**Global Nuclear Fuel**

Subject: Response to Request for Additional Information (RAI) Regarding the New Powder Container (NPC)

References: (1) Docket 71-9294, USA/9294/AF-85, TAC No. L23355  
(2) Letter, C. Vaughan – GNF-A to E. William Brach – NRC, Dated 8/1/01  
(3) Letter, N. Osgood – NRC to C. Vaughan – GNF-A, Dated 8/15/01

**Chapter 1.0, Revised Drawing 0019D0007 as Revision 3**

Figure 2.10.1-1 - OCA Lid Perpendicular-to-Foam Rise (15 Lbs./Ft<sup>3</sup>)

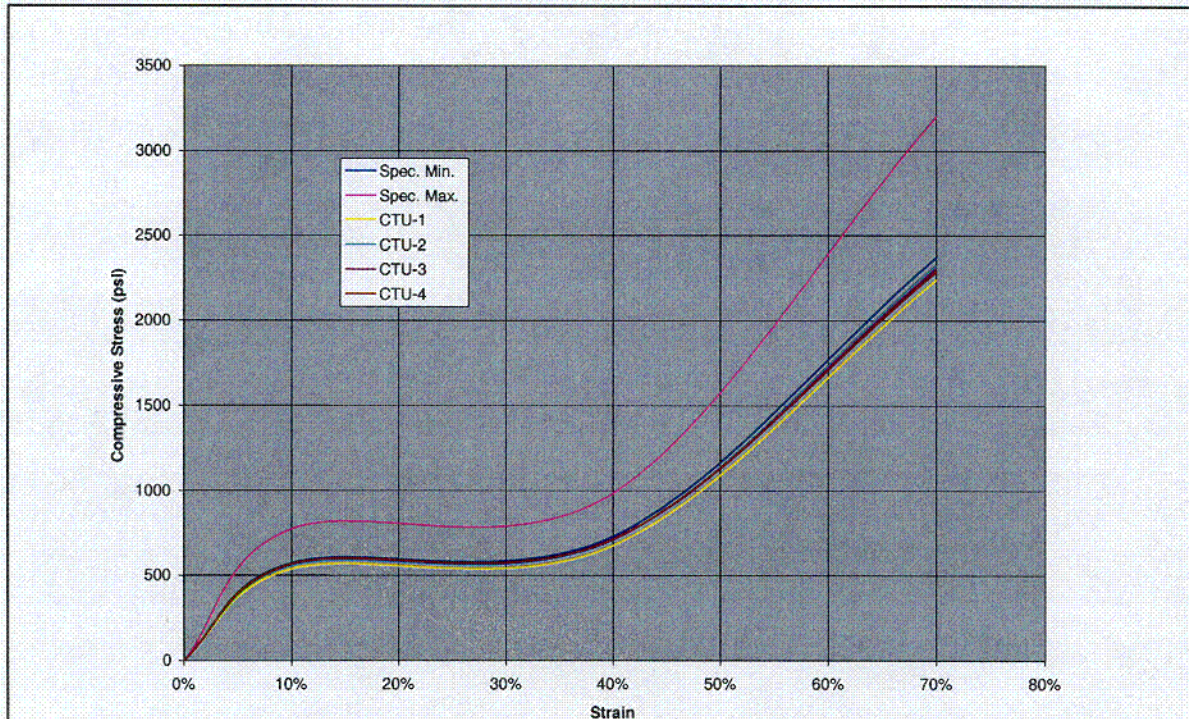
<u>Location of Changes in the Current SAR</u>	<u>Description of Change</u>
Chapter 1.0, Drawing 0019D0007, Revision 3, Zone F3	0.65 was transposed. Should read 0.56
Chapter 2.0, Page 2-20, Figures 2.10.1-1 and 2.10.1-2	Correction to the graphic presentation of the CTU foam curves
Chapter 2.0, Page 2-21, Figures 2.10.1-3 and 2.10.1-4	Same as above

During the preparation of graphics in support of this current response, which compare the certified CTU foam compressive strength values with the proposed specifications, we noted some unexpected inconsistencies when compared to the curves currently in SAR Figures 2.10.1-1 through 2.10.1-4. Upon investigation we found two minor clerical errors and an incorrect adjustment factor were used in the plotting of the CTU values. While the impact of these errors is small, it is noticeable when comparing the curves to the specified acceptance curves. We have therefore provided corrected curves for Figures 2.10.1-1 through 2.10.1-4 (Attachment 2) as replacement pages (pages 2-20 and 2-21) to the SAR. To ensure their accuracy, all plotted data now presented was traced back to the data packages corresponding to the four CTUs. It is most important to note, that the corrected figures do not change any conclusions that were derived from the original graphs; i.e., as shown by the attached curves, CTU foam strengths were indeed at the low end of the range of strength values specified for production units as desired and as previously claimed.

CTUs Compared to New Specifications (cf Figure 2.10.1-1)  
NPC OCA Lid - Perpendicular-to-Rise Stress (15 pcf)

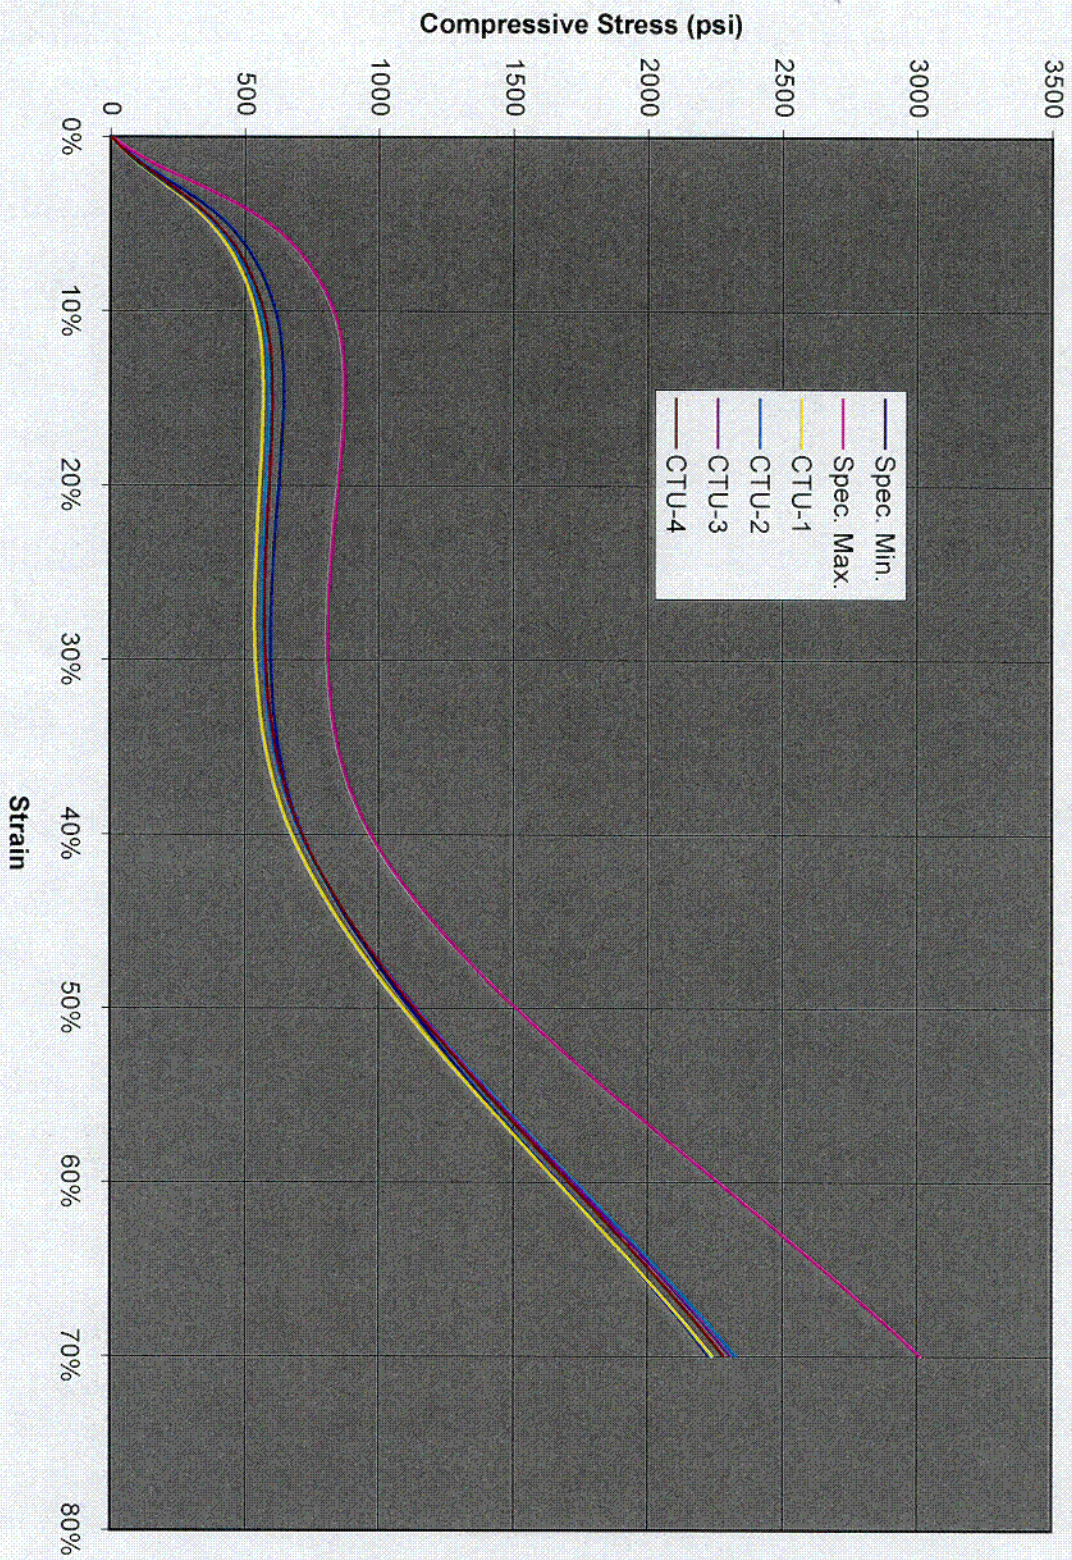
compressive strength of the foam in the four test units was generally on the low side of nominal. To demonstrate this is true for the newly proposed specification, a set of graphs, comparable to Figures 2.10.1-1 through 2.10.1-4, are included in Attachment 3. These graphs compare the CTUs with the proposed new foam specification and should aid in the comparison of the old and new specification values and allow for a determination of the acceptability of the new specification values.
